Remarks

Applicants: SLOWE et al.
Appl. No. 09/956,971

FIG. 4

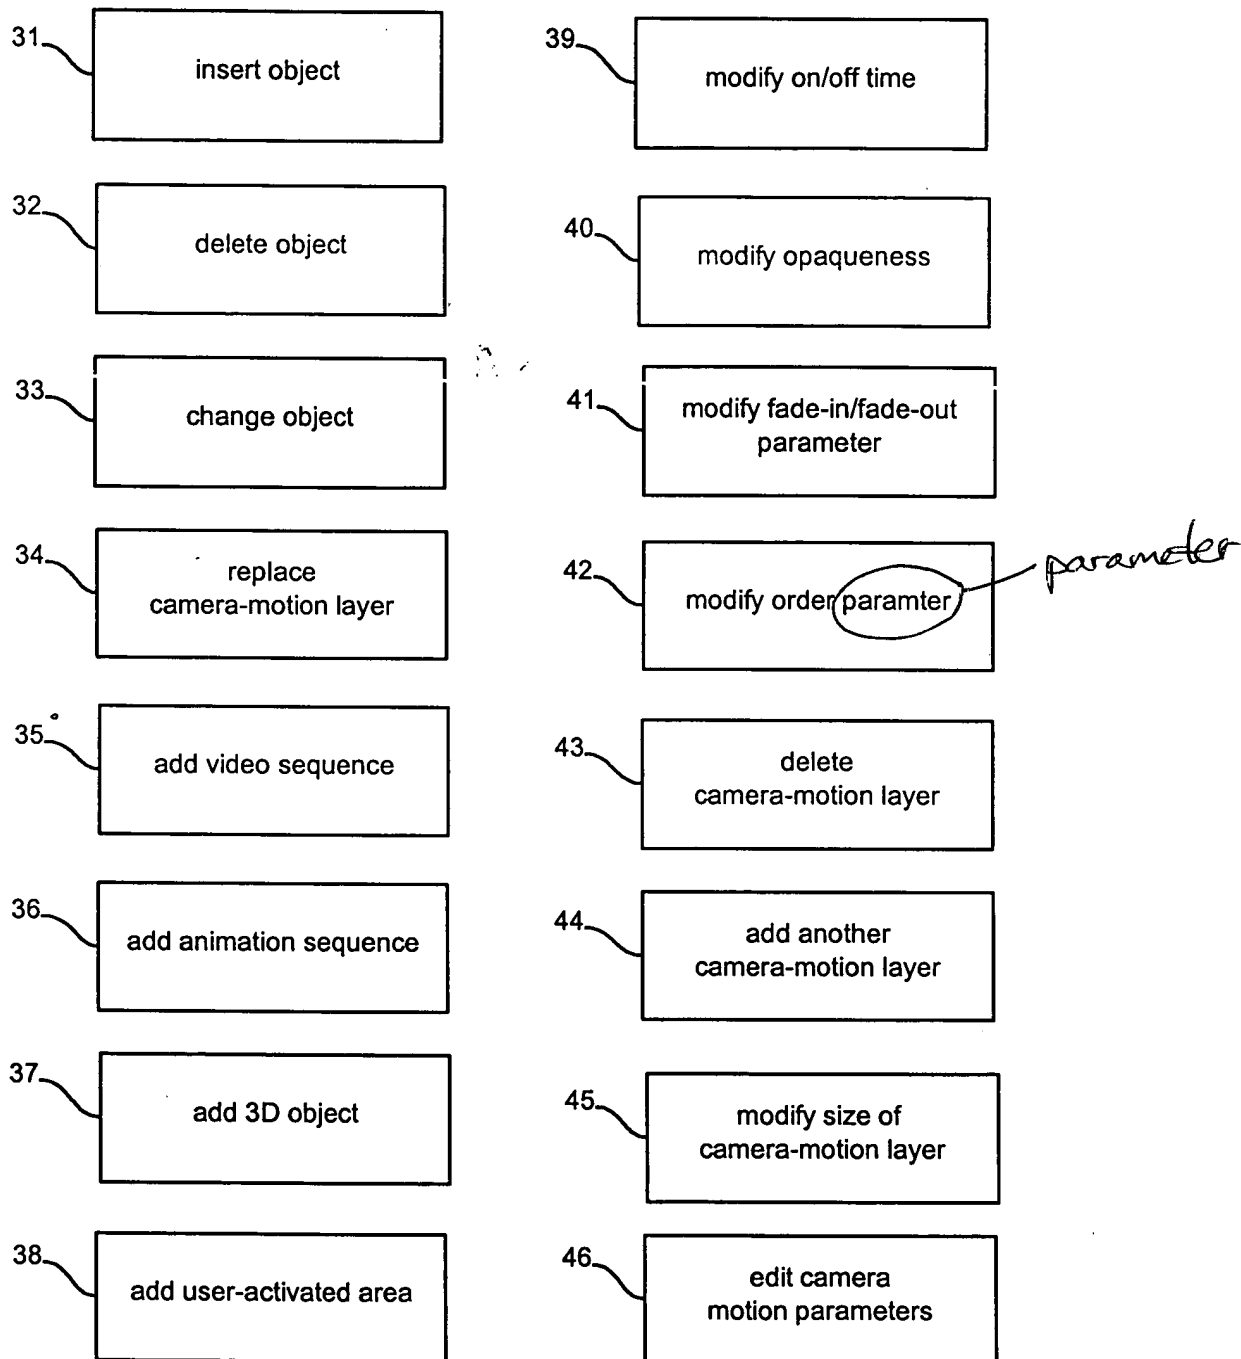
Figures 4 and 6 have been amended to correct misspellings (both of the word "parameters"), only one of which (the latter) was noted in the objection to the drawings at Page 2 of the Office Action.

The two attached sheets of drawings include changes to Figs. 4 and 6. These two sheets include, respectively, Figs. 4 and 6, and replace the corresponding two original sheets of drawings. In Fig. 4, Block 42 and in Fig. 6, Block 76, a spelling error has been corrected.
